5 SUB2010-00117

FRED & MILDRED JOHNSON FAMILY SUBDIVISION

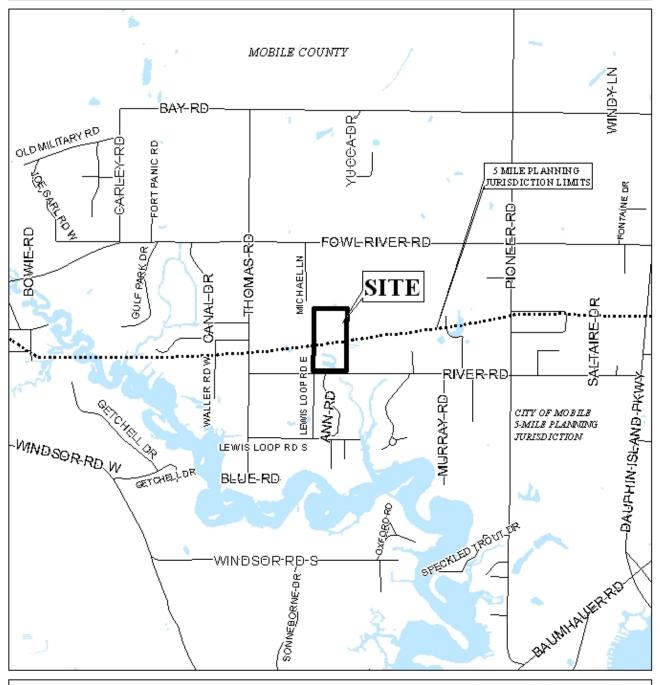
The plat illustrates the proposed 2 lot, $20.0 \pm$ acre subdivision which is located on the North side of River Road, $2/10\pm$ mile East of Thomas Road. The applicant states that the subdivision is served by public water and individual septic systems.

The site fronts onto River Road, a minor street with adequate frontage. The overall site has approximately 667 feet of frontage onto River Road, thus each lot should be allowed one curbcut each, with the size, design and location to be determined by County Engineering, and to comply with AASHTO standards.

The applicant proposes that Lot 1 be a "flag" lot, with a 60 foot wide by 772 foot long pole connecting the lot to River Road. There are no Planning Commission approved flag-lots in the vicinity, and this is the first subdivision application for this area since the Theodore/Tillman's Corner annexation expanded the Planning Jurisdiction to the South: the jurisdiction line in fact cuts the site in half.

The same subdivision was approved by the Planning Commission at the August 19, 2010 meeting, but has been re-submitted with the pole being changed from 25 feet to 60 feet and being moved from the West of the lot to the East side. These changes also changed the size of Lot 1 to $9.1 \text{ acres} \pm \text{ from } 8.4 \text{ acres} \pm \text{.}$

also contains a small lake which complicates the ability to divide the 20 acre property. As proposed Lot 1 will be 9.1 acres in size, with a pole of 60-feet in width. Future resubdivision of Lot 1 should be not be allowed until such time that additional frontage on a public street or compliant private street is provided.

The 25-foot minimum building setback is shown on the plat for both lots as required by V.D.9 of the Subdivision Regulations, and should be retained on the Final Plat, if approved. The lot sizes are depicted on the plat in square feet and should be retained on the Final Plat, if approved.

- Retention of the note on the Final Plat stating that each lot is limited to one curb-cut, with the size, design and location to be approved by Mobile County Engineering and to conform to AASHTO standards;
- 2) Retention of the depiction and labeling of the 25-foot minimum building setback line, and with the setback line for Lot 1 to be setback from where the "pole" meets the "flag" portion of the lot; and
- 3) Retention of lot area size labeling, in square feet, on the Final Plat;
- 4) The pole for Lot 1 remains a minimum of 60-feet wide;

5) Retention of the note on the Final Plat stating that there shall be no future subdivision of Lot 1 until additional frontage is provided on a public street or a private street developed in compliance with the Subdivision Regulations;
